# Access Compliance Report

## Public Rights-of-Way

### (Curb Ramps)

Intersection ID: 30450	Main Street: STEELE_CREEK_RD	Cross Street: SMOKE_MONT_DR	Location: SW
ADA ID: 1658F114C56B	Ramp Type: Perp	Initial Pass/Fail: Fail	Overall Compliance: No
		Severity Score: 25

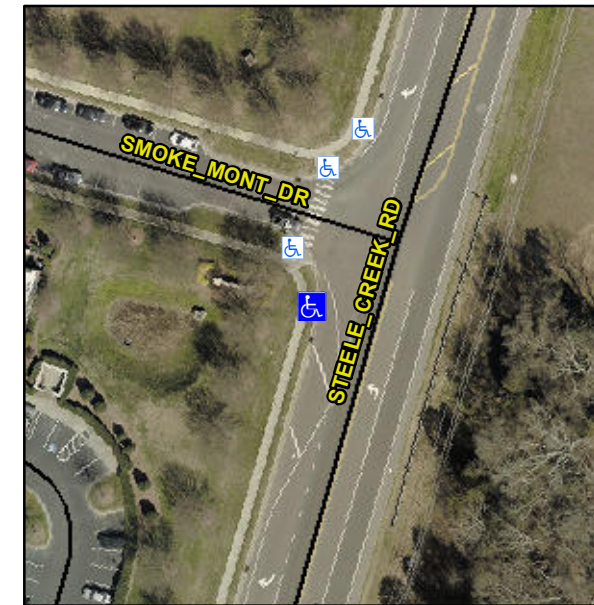
**Not Found, R304.2.2**

Compliance	Description	Data	Compliance	Description	Data
N/A	Ramp Length (in)	56.0	No	Ramp Slope (%)	12.6
Yes	Ramp Width (in)	48.0	Yes	Ramp XSlope (%)	1.0
N/A	Flare Type LT	N/A	N/A	Flare Type RT	N/A
N/A	Flare Slope LT (%)	N/A	N/A	Flare Slope RT (%)	N/A
N/A	Flare Traversable LT?	N/A	N/A	Flare Traversable RT?	N/A
N/A	Landing Length (in)	N/A	N/A	DWS Provided?	N/A
N/A	Landing Width (in)	N/A	N/A	DWS Contrast?	N/A
N/A	Landing Slope (%)	N/A	N/A	DWS Length (in)	N/A
N/A	Landing X Slope (%)	N/A	N/A	DWS Full Width?	N/A
N/A	Landing Curb? (Y/N)	N/A	N/A	DWS Offset (in)	N/A
N/A	Shared Landing?	N/A			
N/A	Gutter Ponding?	N/A	N/A	Gutter Slope (%)	N/A
N/A	Gutter Lip Ht (in)	N/A	N/A	Gutter X Slope (%)	N/A
N/A	Painted X Walk1?	No	N/A	Painted X Walk2?	N/A
	X Walk 1 Direction	To SE		X Walk 2 Direction	N/A
N/A	X Walk 1 Width (in)	N/A	N/A	X Walk 2 Width (in)	N/A
	X Walk 1 Slope (%)	4.6		X Walk 2 Slope (%)	N/A
	X Walk 1 X Slope (%)	0.8		X Walk 2 X Slope (%)	N/A

**Remove & Replace Entire Ramp.**
